Project:
NPTH Modular Orthopaedics

Title:
Proposed Foul Water Drainage Layout

Drawn: KJW	Checked: ABP	Scale(s) at A1: 1:100
Date: 01.03.22	RVW Job N°: C7040	Revision: P2
Drawing Status: PRELIMINARY		Suitability: S0
Drawing N°: C7040-RVW-ZZ-00-DR-C-202

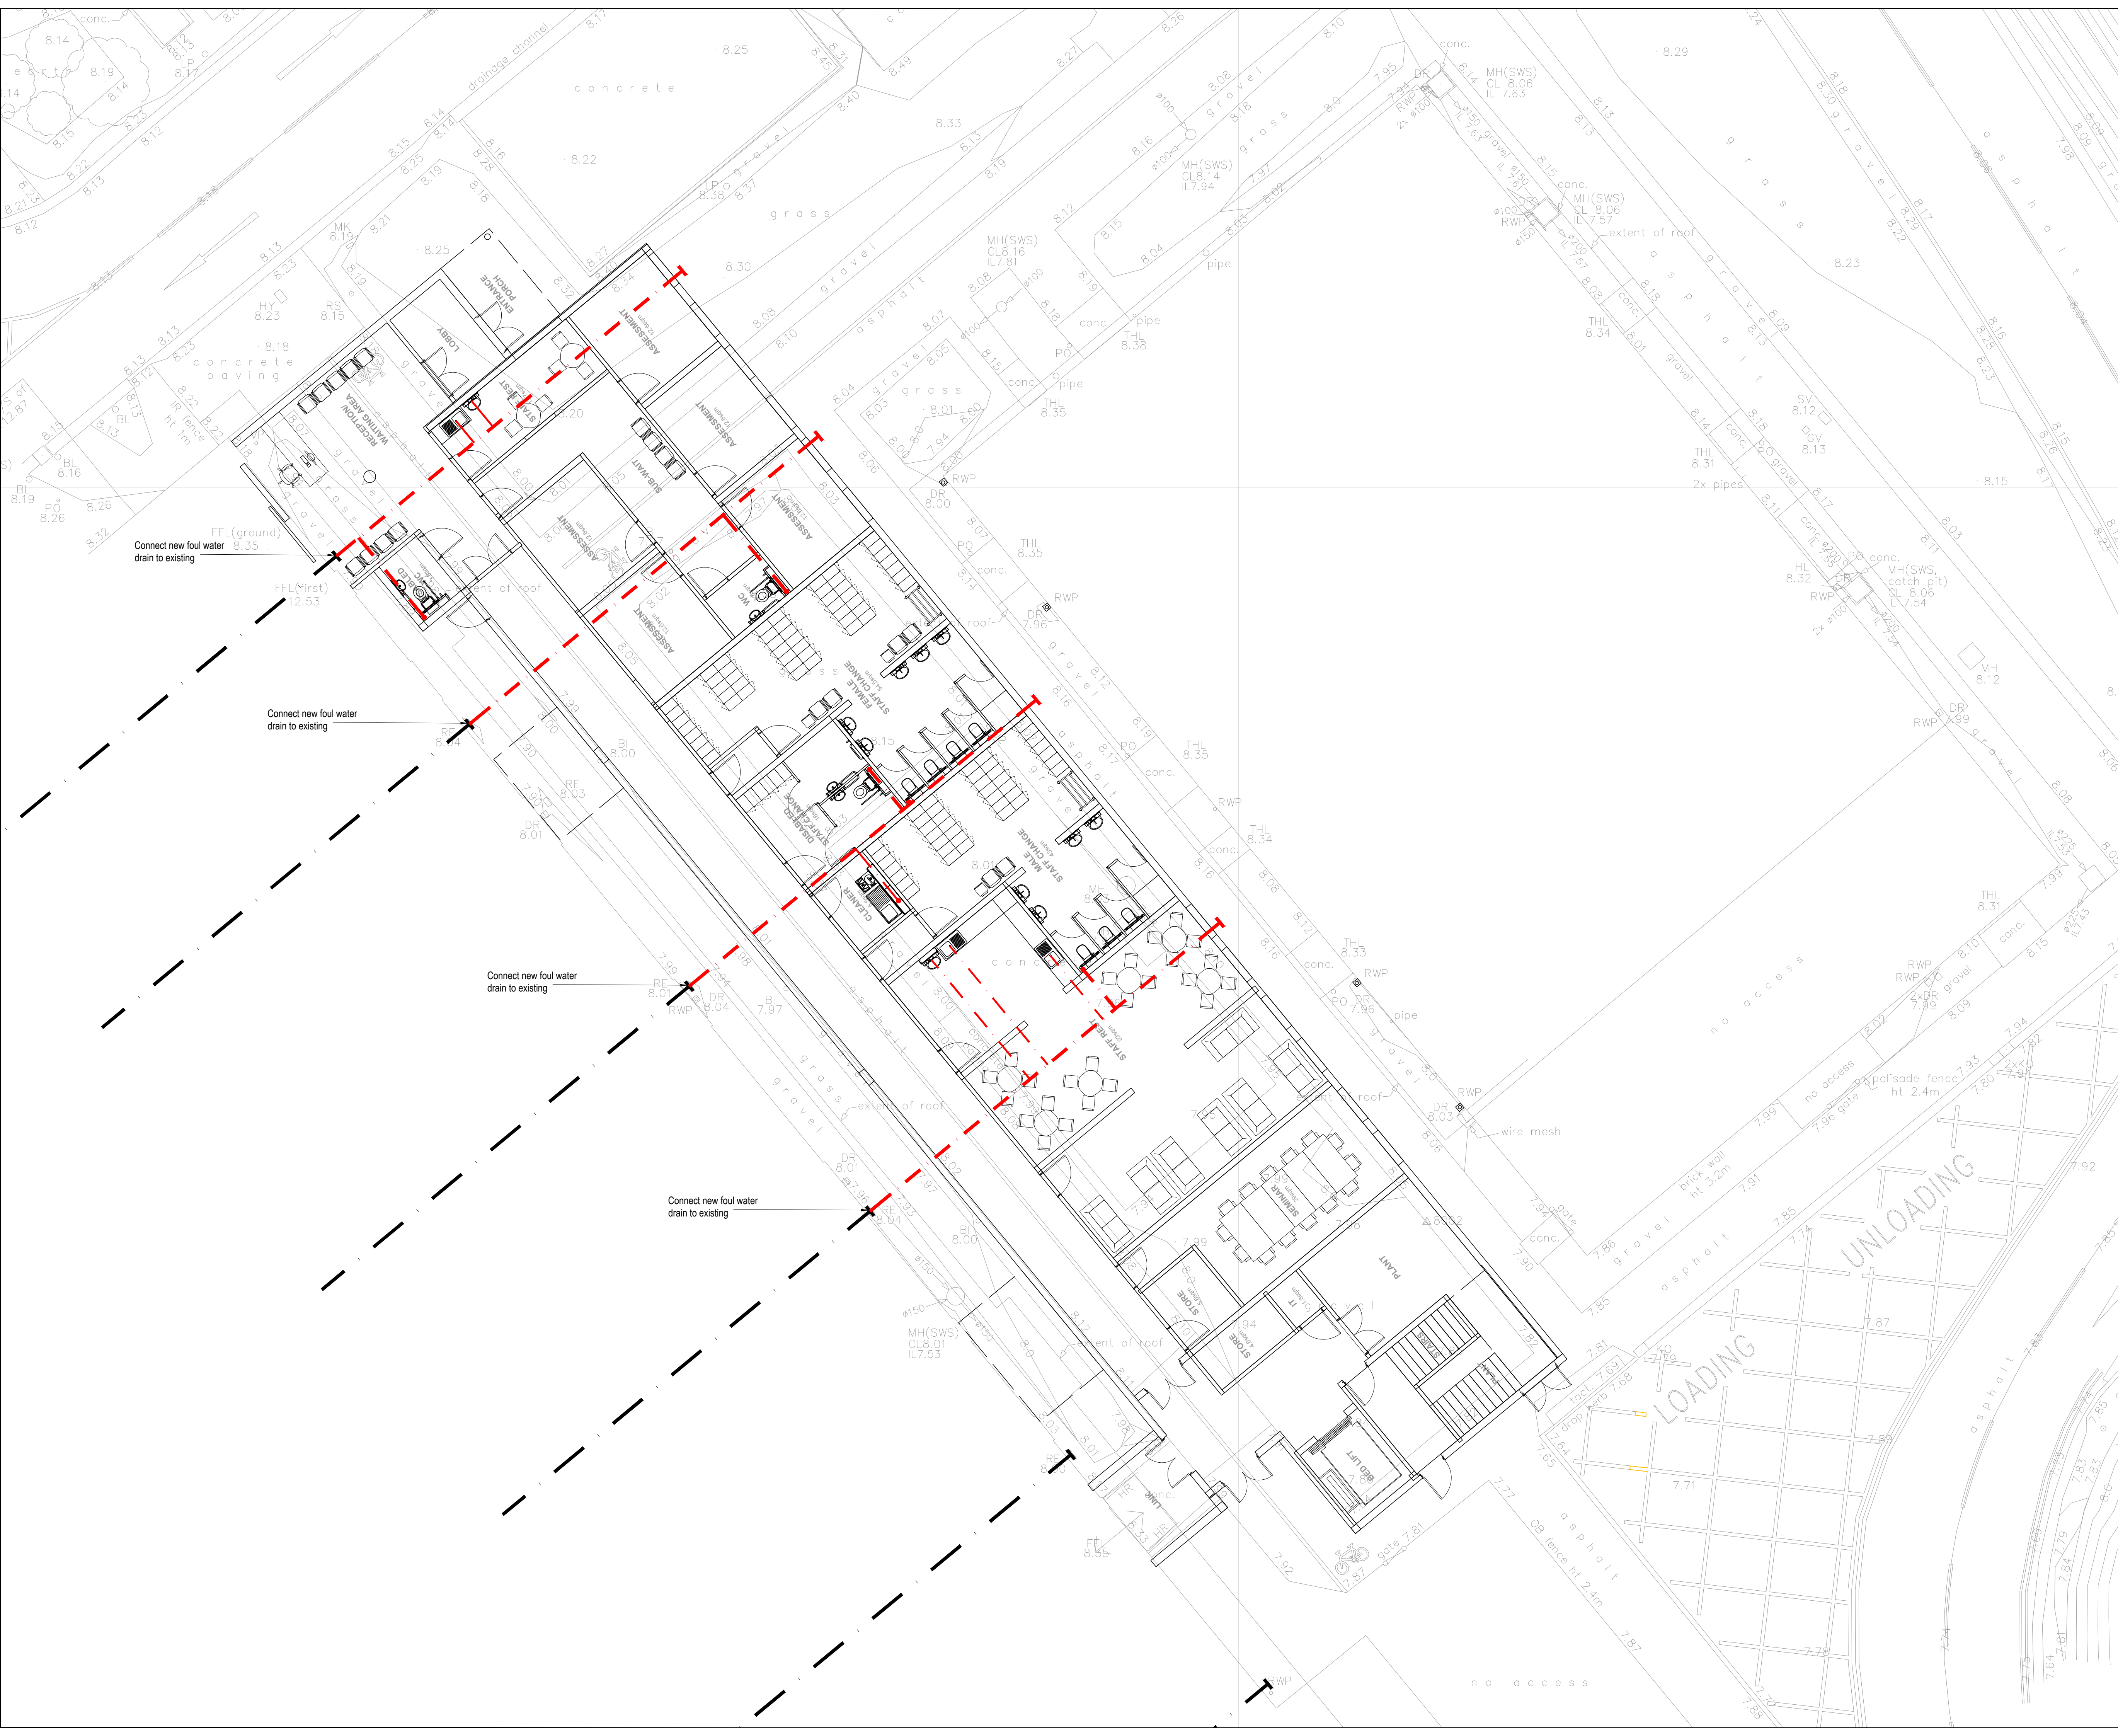
P2	15.03.22	kerbing changes in loading bay area deleted as to remain as existing.	ME	ABP
P1	01.03.22	PRELIMINARY ISSUE	KJW	ABP
Rev.	Date.	Details.	By.	Chk.
